# CITY OF ALBUQUERQUE

**Re: Dutch Bros Coffee**  
**10001 Central Ave NE**  
**Request for Certificate of Occupancy- 30 Day Temp**  
**Transportation Development Final Inspection**  
Plan Approval Date 2-15-23 (L20D048)  
Certification dated 1-27-24

TCL & PAVING PLAN

CP-101

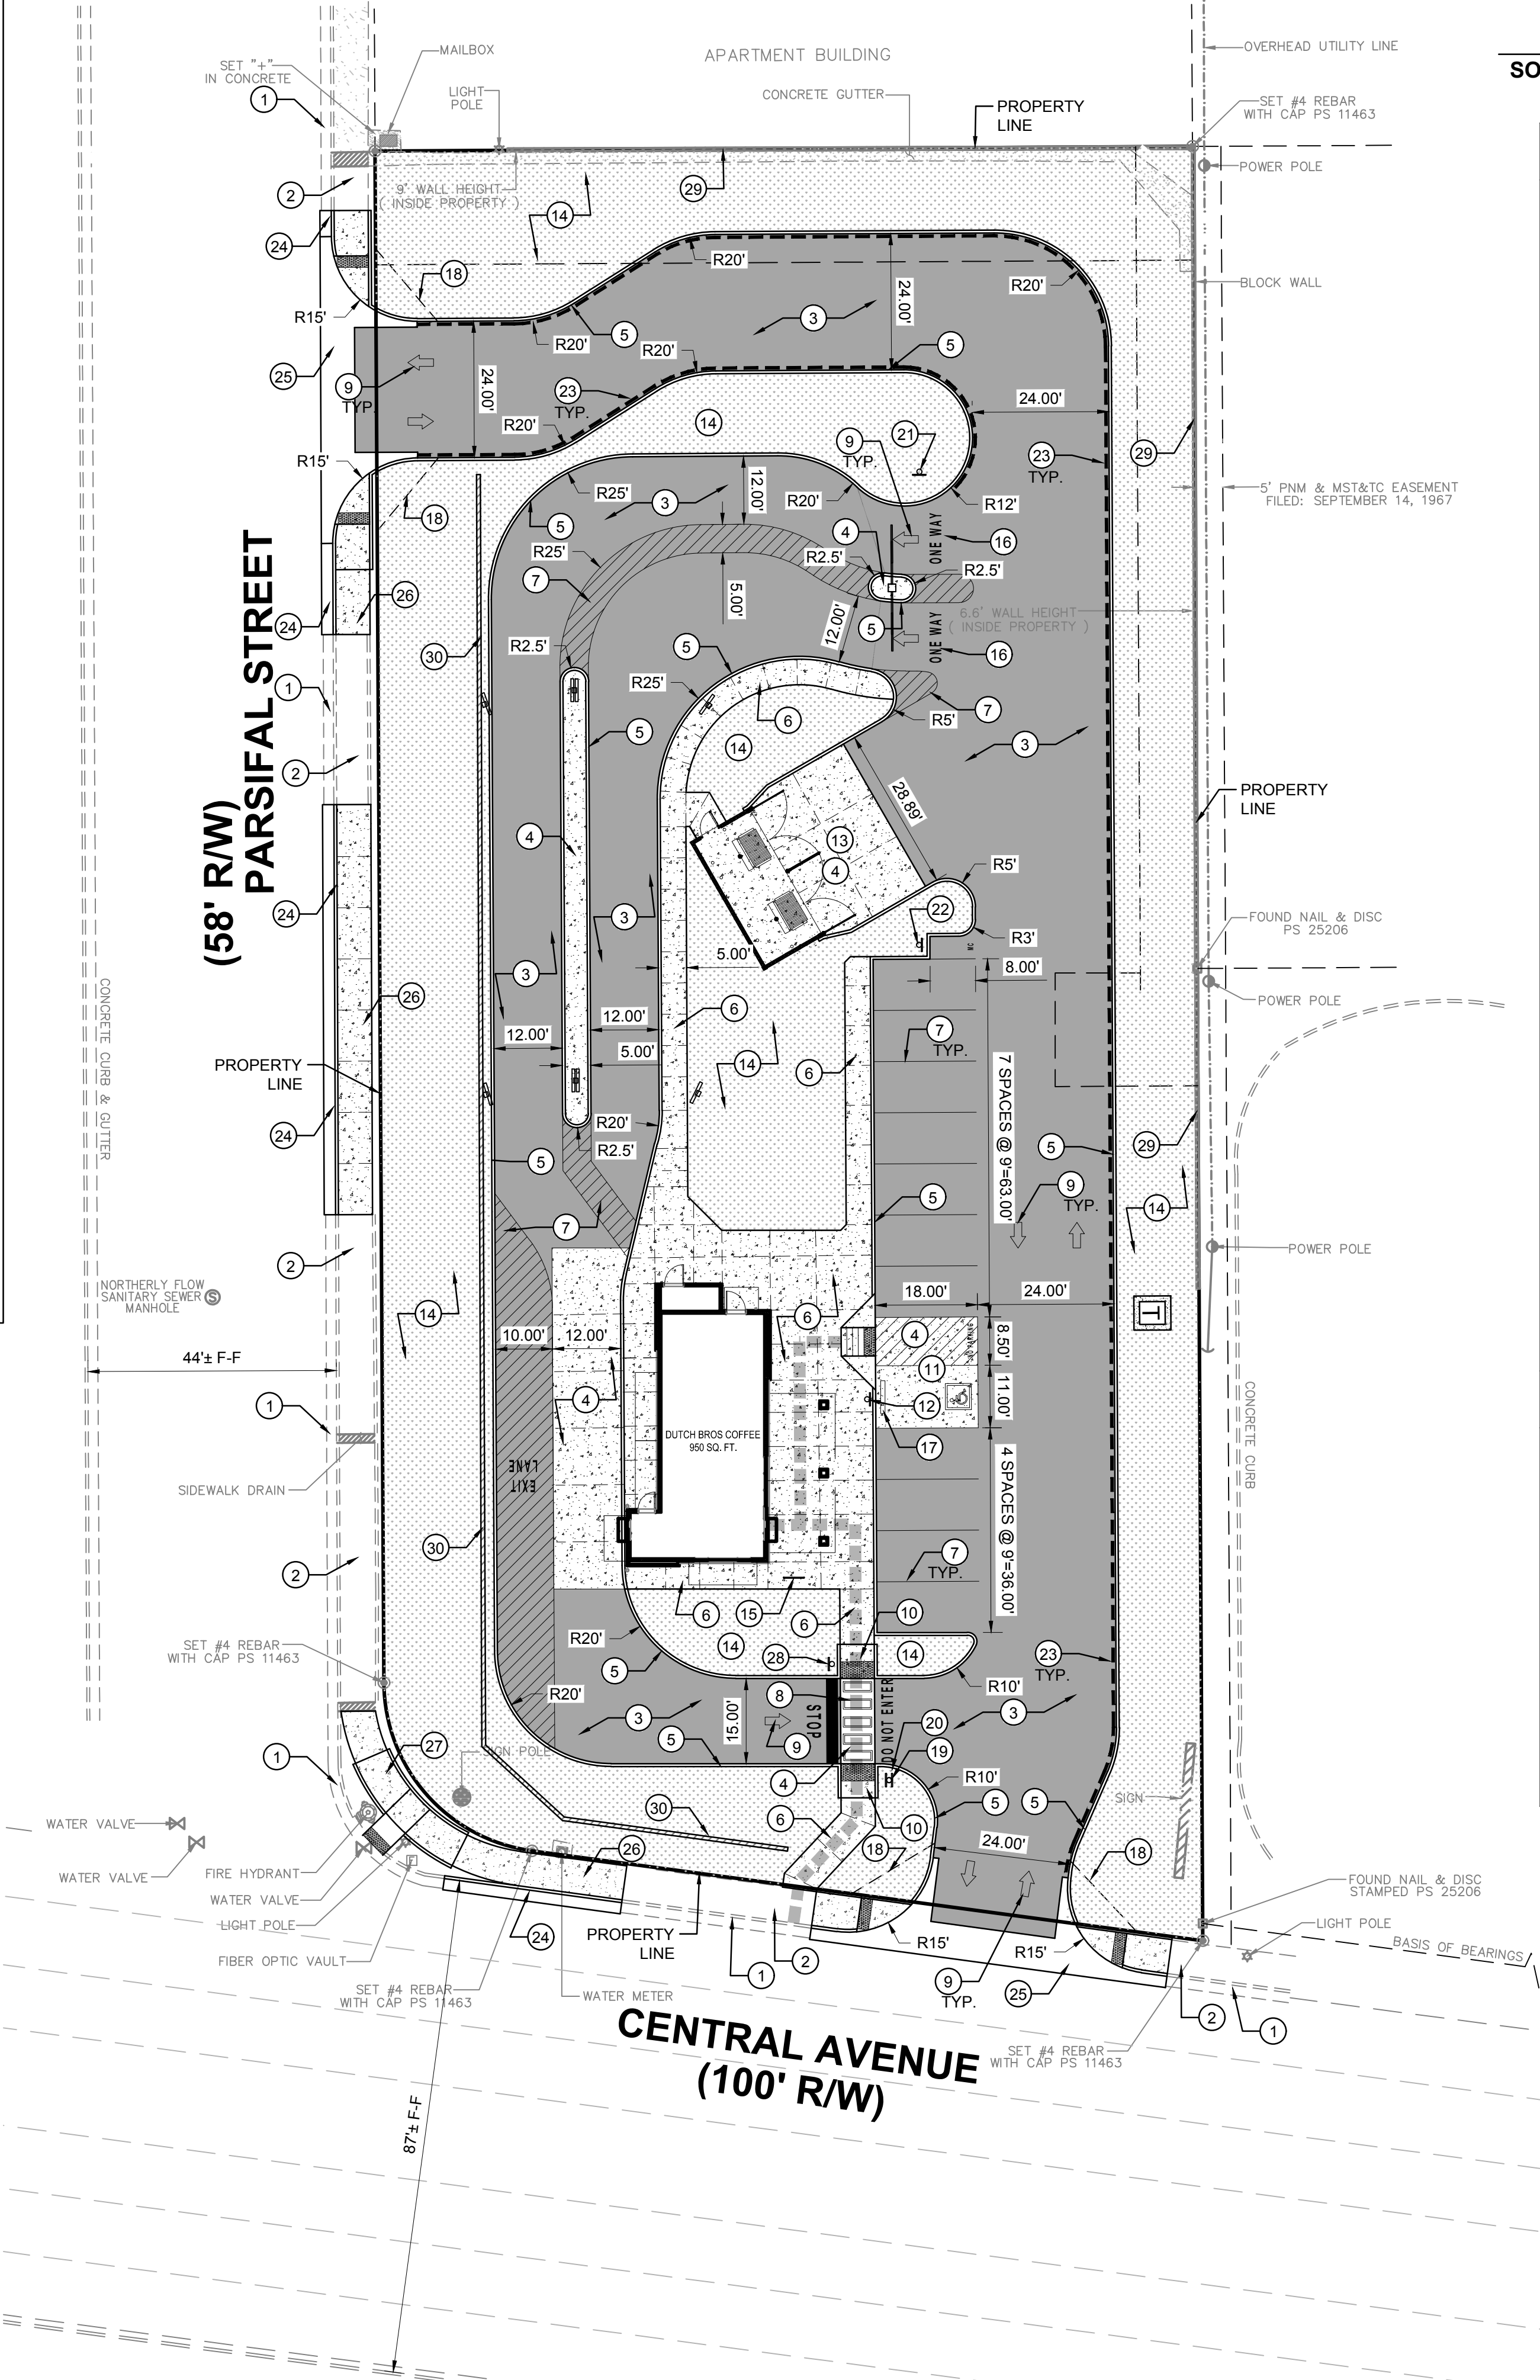
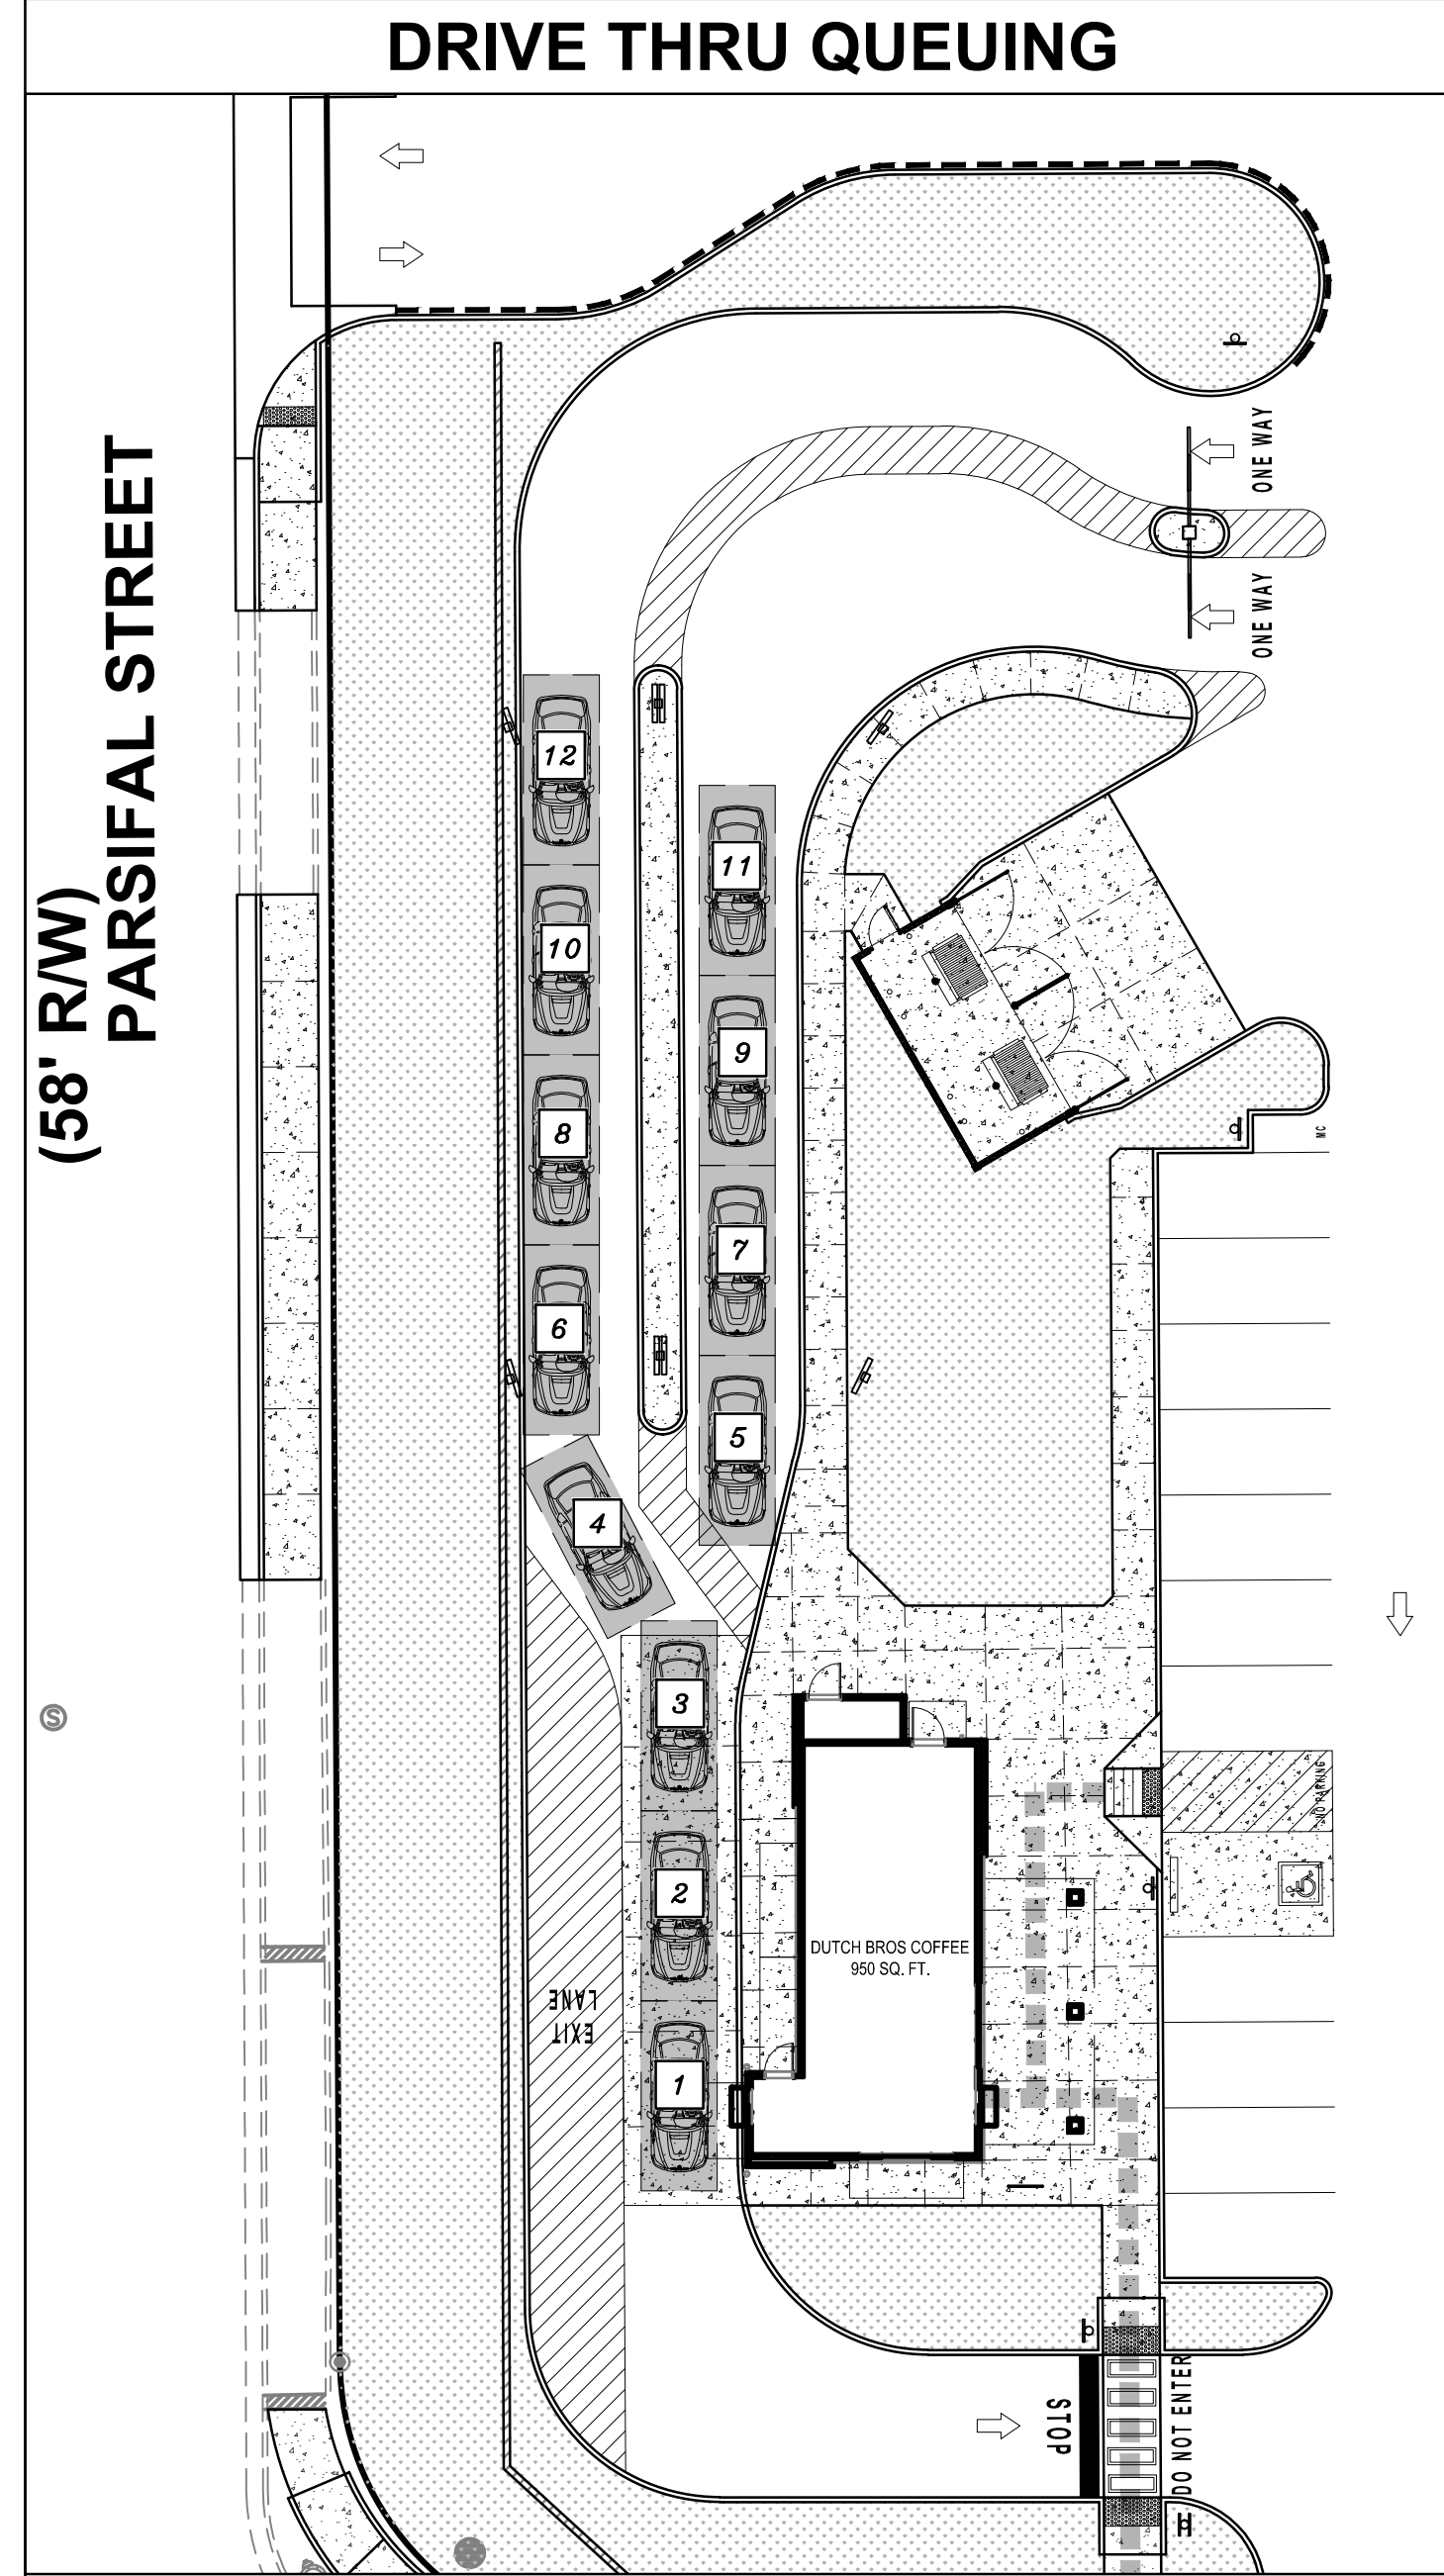
1. Two sidewalk stones along Parsifal St. are to be replaced: one is broken just south of the entrance and the other is a trip hazard and is broken just north of the sidewalk culvert. The stones were shown to the Superintendent.
2. The Pubic ramp at the southwest corner of the site is only 43" wide. City Specifications specify a minimum of 5' wide, however, the DPM allows for 4' wide. It appears there is room to widen the ramp/pedestrian path to 4'. Please let me know if you think the location of the light pole and fire hydrant do not allow the ramp/pedestrian path to be widened to 4'. In addition, the ramp may function better if it were pointed more to the west.
